EAL 2024 IRP Stakeholder Committee Questions

92. Referring to slide 9:

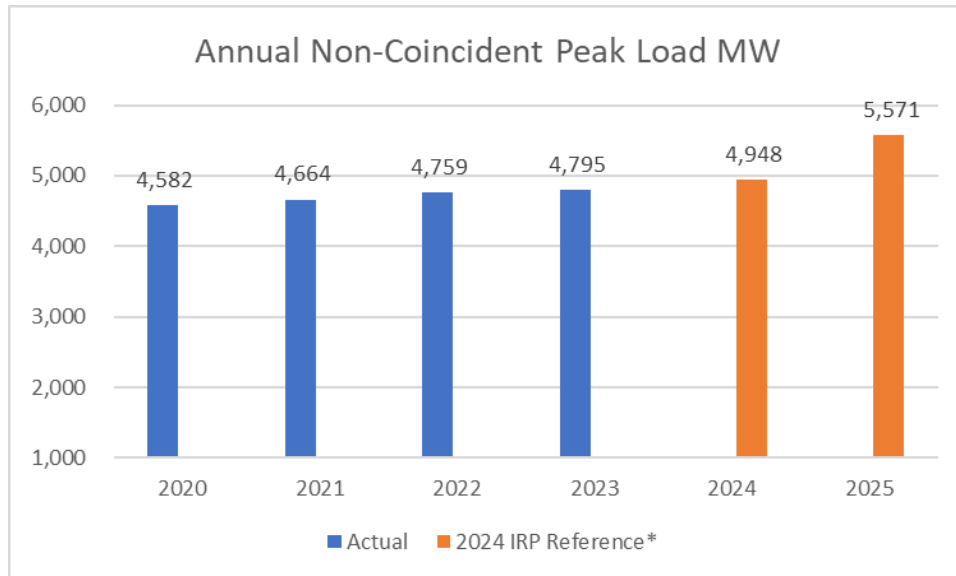
a. Please define and explain how EAL will pursue power resilience. What assets are used to secure power resilience?

See response to question No. 14. EAL evaluates options for power resiliency.
